RESPONSE LETTER

Flatt Point Subdivision (OPA, ZBA, DPS, DPC) - 3401 County Road 13

Prince Edward County

Technical Review Comments (September 19, 2025)

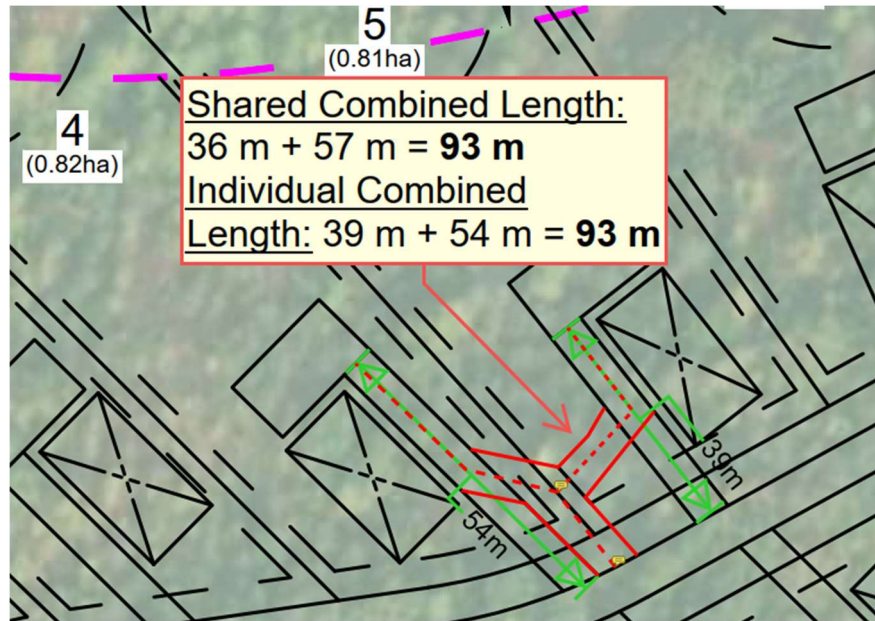
7. COMMENT: The Shore Land design concepts illustrated in Appendix A of the Official Plan all use shared driveways to facilitate access to individual lots. The use of shared driveways would reduce hardscaping and provide for more efficient ingress/egress. Please consider incorporating shared driveways into the next submission.

RESPONSE: We had reviewed the various “Shore Land Subdivision Concepts” previously as the original and revised plans were prepared, including the idea of shared driveways. In principle, a shared driveway is presented as a way to reduced hardscaping and limit the number of entrances on a road. We note that not all Concepts and not all lots in the Concepts show shared driveways. We also note that their value and practicality can be limited.

Regarding the number of entrances, while shared driveways do limit the number of individual entrances, each of the 16 lots having their own entrance to the condo road is not anticipated to present a traffic issue given the nature of the condo subdivision road as a cul-de-sac road with no thru-traffic. Shared driveways are typically more likely to be considered and implemented where accessing a busier road and/or a road with limited sight lines or access opportunities.

Regarding the benefit of shared driveways to reduce hardscaping, this is not always the case with shared driveways, particularly where their length is shorter. This is due to the fact that the required additional driveway length parallel to the road from the shared access point can negate any reduced length achieved by the shared entry portion. Please see Figure 1 below for an illustration of a theoretical shared driveway between Lots 4 & 5 that results in a total length of driveway that is the same as individual driveways (93 m).

Practically speaking, shared driveways do present some challenges for long-term shared maintenance between two private property owners. While the Condominium Corporation associated with the condominium road creates the mechanism for sharing of maintenance, insurance and other costs, a shared driveway on the private subdivision parcels would be outside of the condominium and therefore it would fall to the individual property owners to manage shared maintenance and cost, which is less preferable than individual ownership. The

Official Plan does not provide direction or appear to contemplate how this element of shared driveways would be managed.

On this basis, it is proposed that individual driveways be maintained as the default approach, but if desired by the municipality, the subdivision design could include the option for a shared driveway approach as part of the detailed design phase (i.e. engineering drawings for Final Plan of Subdivision approval can show an “alternate design” for a shared driveway option).
